Re: Bliffert Lumber & Hardware Addition

On behalf of the City of Waukesha, we have reviewed the application documents dated 12/30/2024 submitted by the Consortium ae LLC for Bliffert Lumber & Hardware Addition.

Project Description

C100

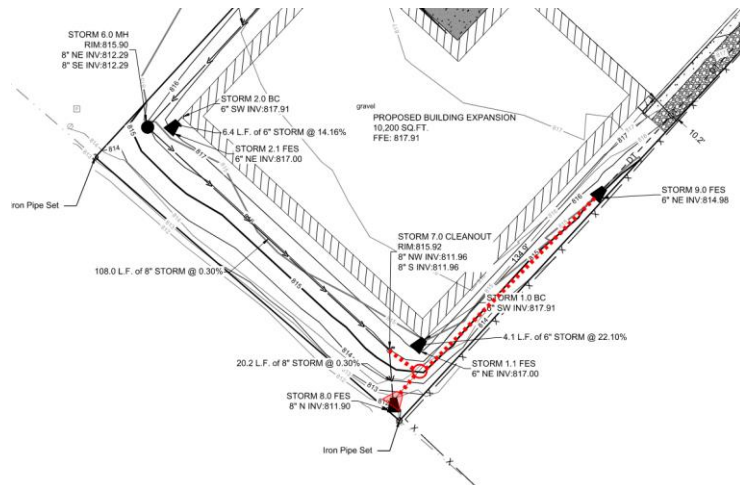
17. Plans show concrete entrance pad on NW property line to an access easement with no recorded documentation. Ensure paving is contained to property limits.
